DESIGN REVIEW BOARD MEETING

CITY OF DAVENPORT, IOWA

Monday, July 28, 2025; 5:00 PM

Case DR25-11: Request for Design Approval, C-D Downtown Zoning District; Storefront remodel at 317 West 3rd Street. Collette's Piano Bar, petitioner. [Ward 3]

# Design Request

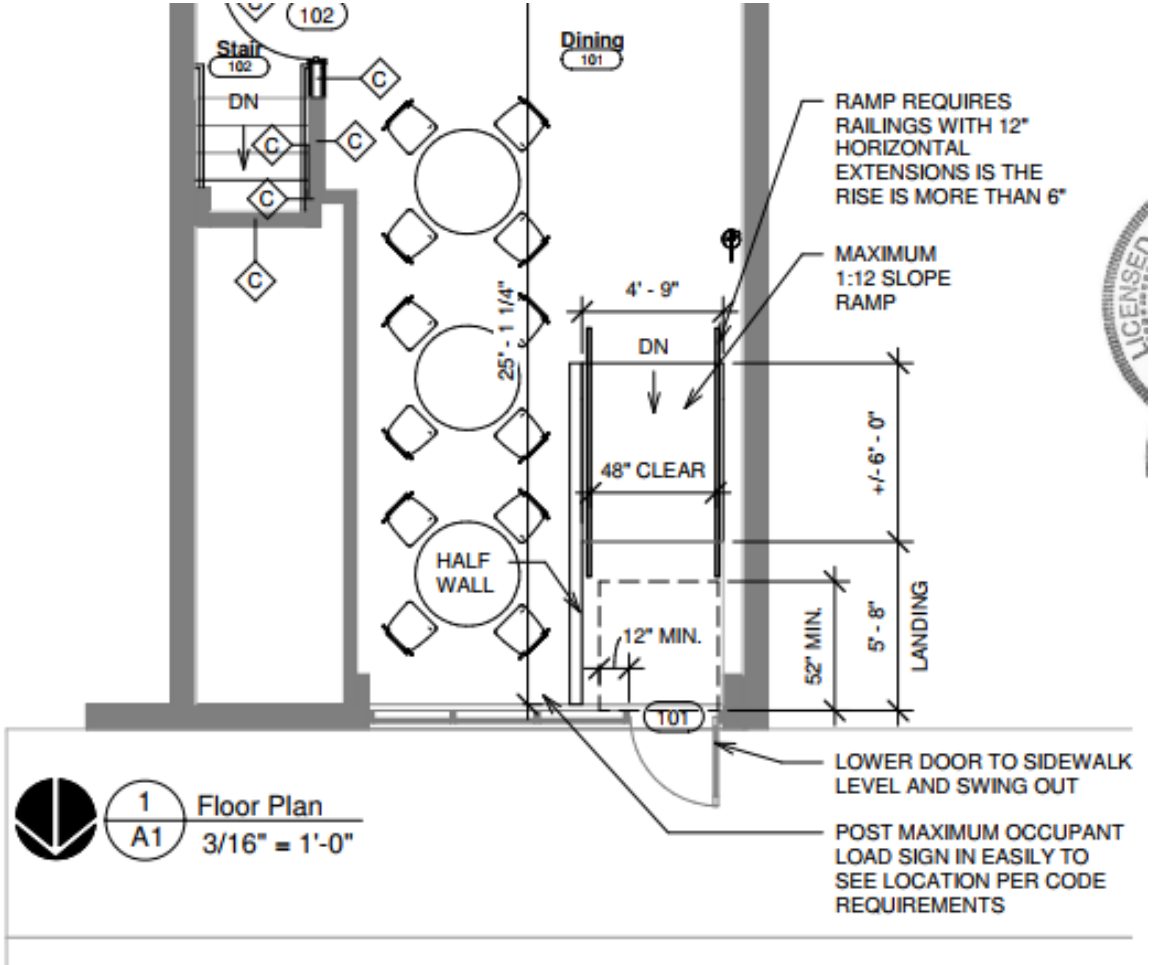
- Lower the main entrance door by 6 inches to be level with the sidewalk grade along 3<sup>rd</sup> Street.
- Required for compliance with ADA standards.
- Door will swing outwards onto the sidewalk.
- Reuse existing door and hardware.
- Infill gap with framing and an opaque panel, matching the tint of the storefront glass.

# Storefront Alteration

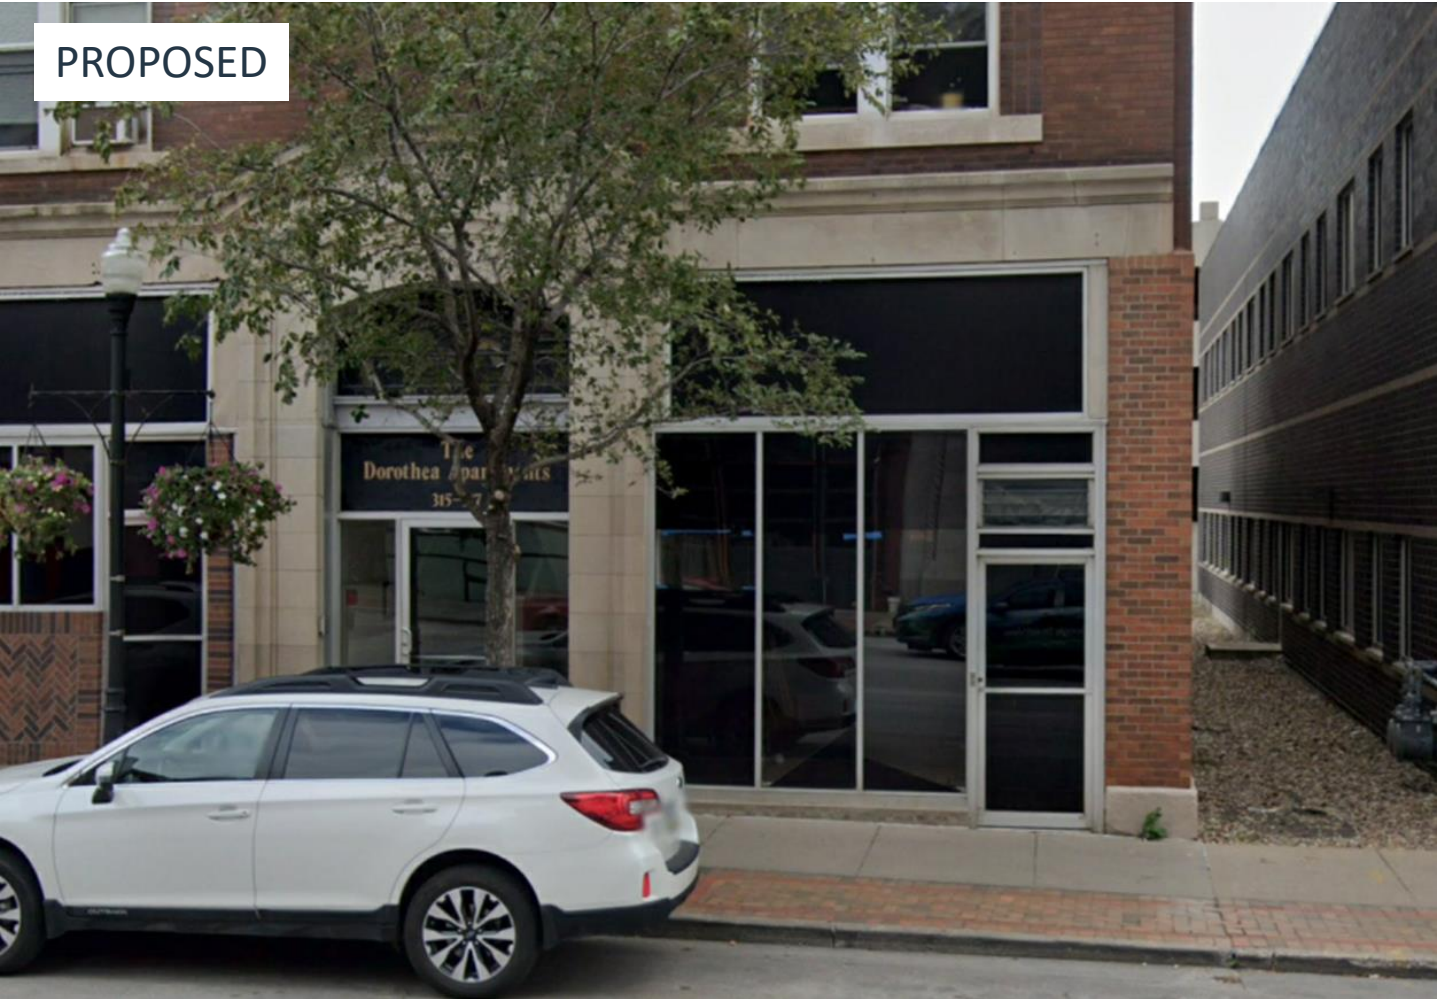
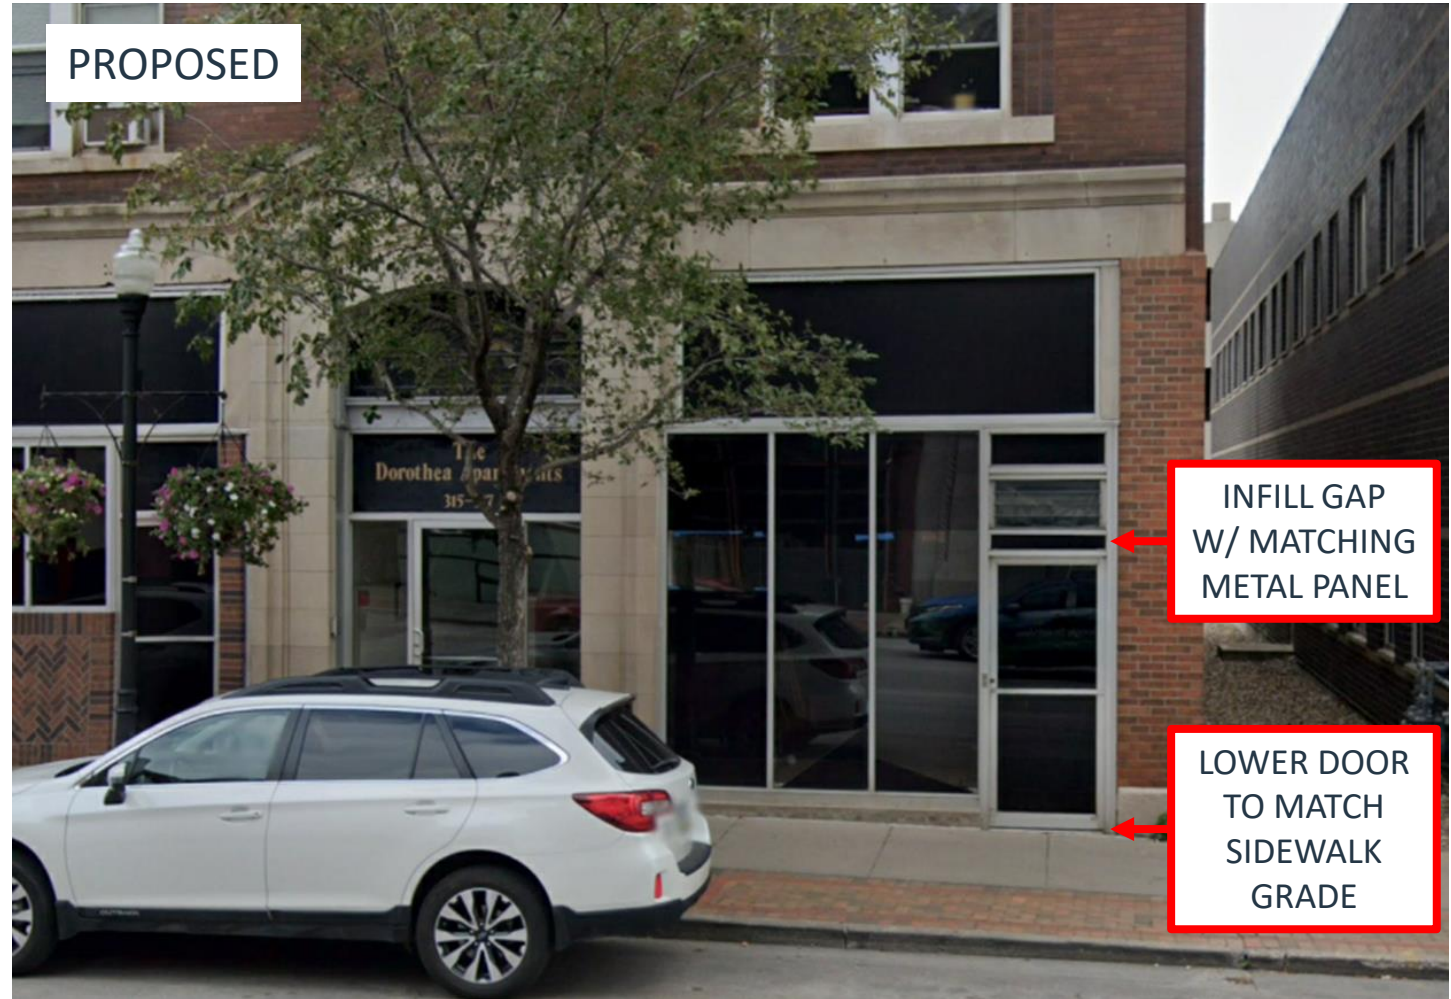
The first floor tenant space on the west corner of the building is being remodeled for a new piano bar. City staff are reviewing construction drawings to retrofit the interior for a full bar, dining area, performance stage, and restrooms. To comply with the Americans with Disabilities Act (ADA), the 3rd Street entrance needs to be lowered to meet the grade of the sidewalk. This will create a gap of approximately six inches between the lowered door and the existing window. The owner intends to infill this space with framing and an opaque panel, matching the tint of the glass and panel over the storefront.

Per a requirement of the International Building Code, the existing push door will be reused and retrofitted to swing outwards onto the sidewalk. The existing hardware will remain. A rendering has been provided by the applicant detailing the proposed alterations to the storefront.

# Design Consideration

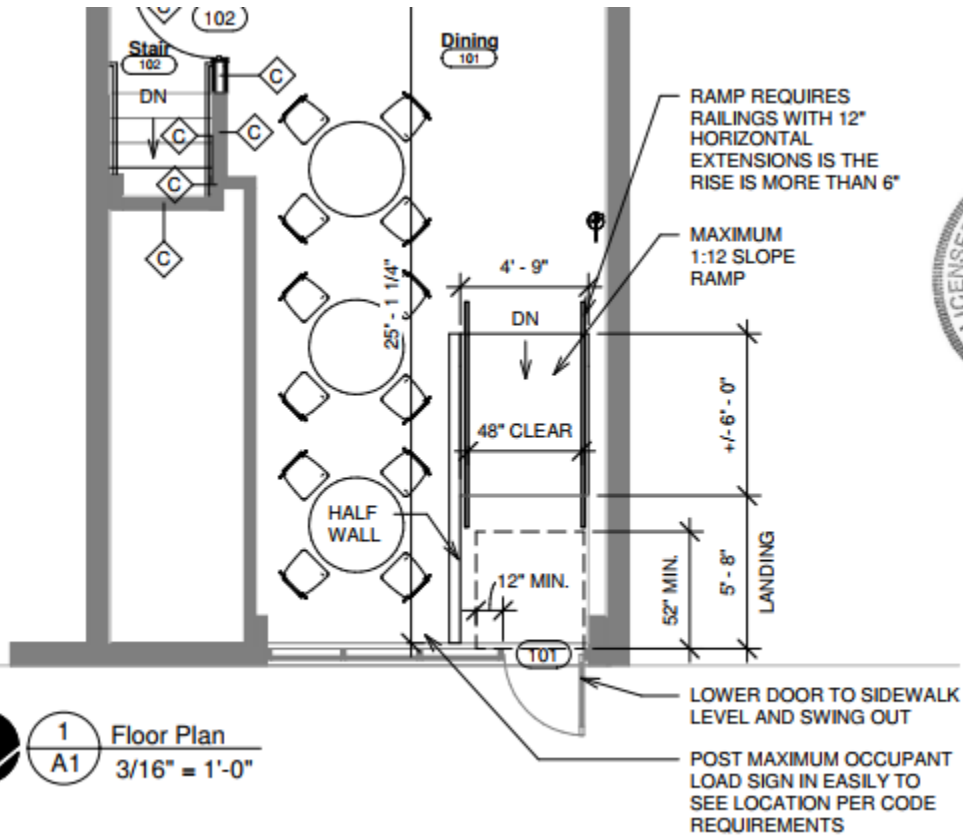
Staff are not opposed to the request as the final design is considered a minor alteration that allows for an adaptive reuse of a vacant downtown commercial space. However, staff believe a more appropriate measure is to remove the existing sections above the door and infill the opening with a single window unit. This would replicate the appearance of the adjacent storefront entrances and provide better consistency to the facade.

- Replace entire opening above the door.
- Install a single window unit to fill the gap.
- Similar to the appearance of the adjacent entrances.
